RESPONSIVENESS SUMMARY
FOR
SUBURBAN WATER SYSTEMS

BARTOLO WELL FIELD
OPERABLE UNIT FEASIBILITY STUDY
SAN GABRIEL AREAS 1, 2, AND 4
LOS ANGELES COUNTY, CALIFORNIA

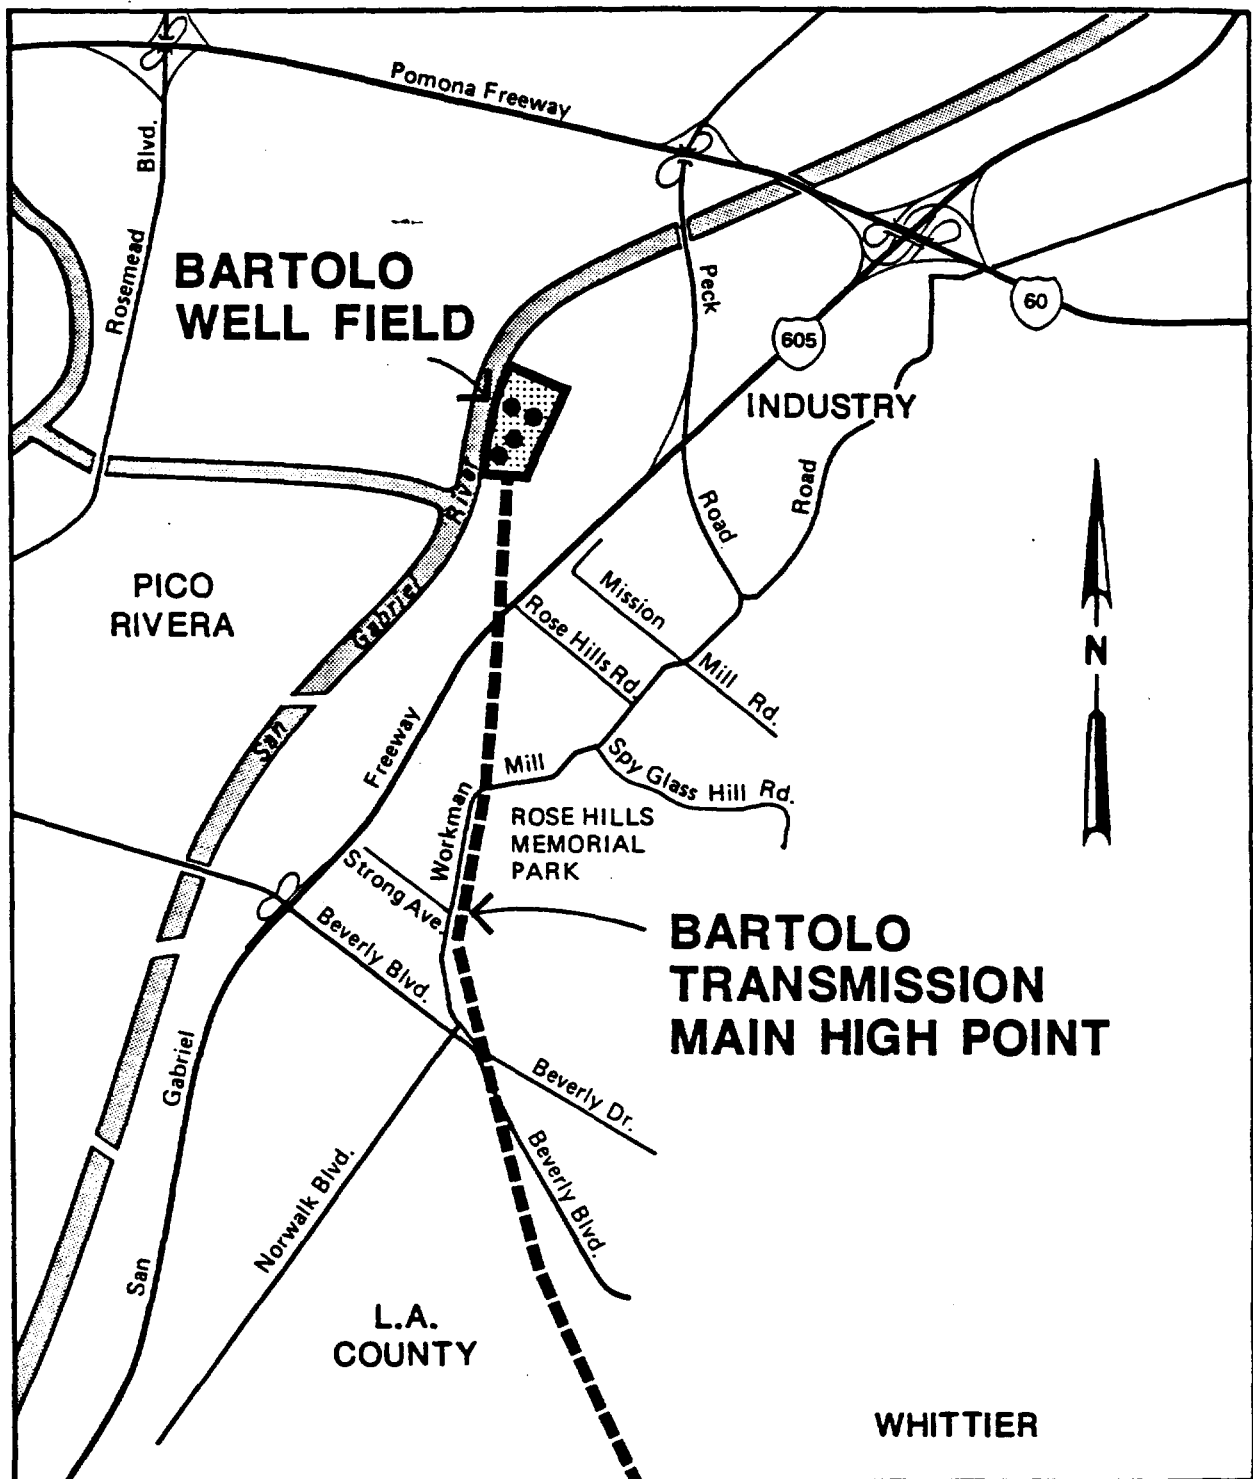
2. One resident requested a more detailed map and explanation of the broken line shown on the map provided in the public meeting notice delivered door-to-door.

EPA Response: The broken line is the approximate route of the Bartolo Transmission Main that transports water from Suburban's Bartolo Well Field to its customers in the Whittier District. Additional detail on the route is shown in Figure 2-4 of the OUFS. Exact routing can be obtained from Suburban Water Systems.
